## Product Change Notification (PCN)

### PLCC Socket - SMT, Tin plating, 44 contacts

Change Notification: PCN-US-20140816 A-CCS-044-Z-SM

Description of changes: CHANGE OF MANUFACTURING LOCATION  
CHANGE TO NEW TOOLS

Part number	Drawing number
A-CCS-044-Z-SM	ASS_0142_COrev06

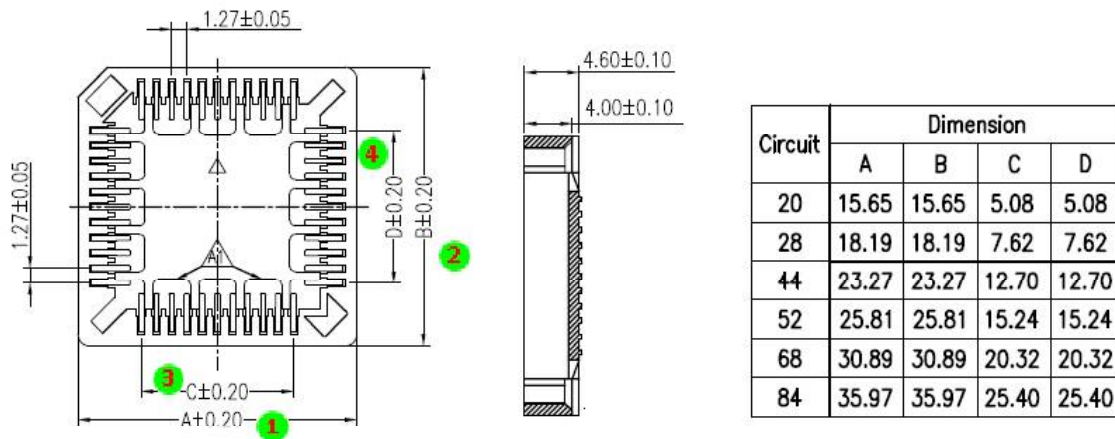
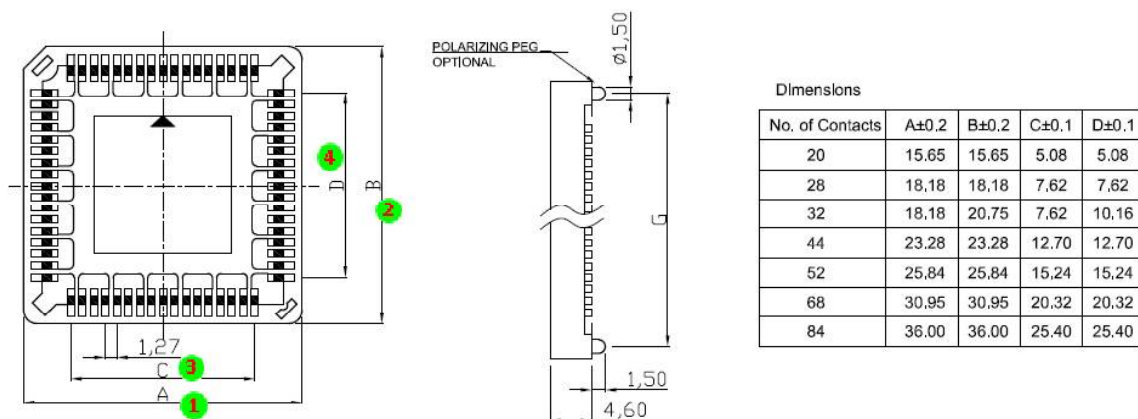
1. Amendment of the specification
2. Change of Dimensions, see sheet 3
3. Drawing # ASS\_0142\_COrev06 replaces all prior drawings

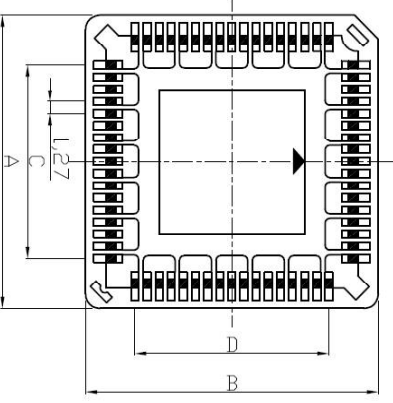
Before change:

After change:
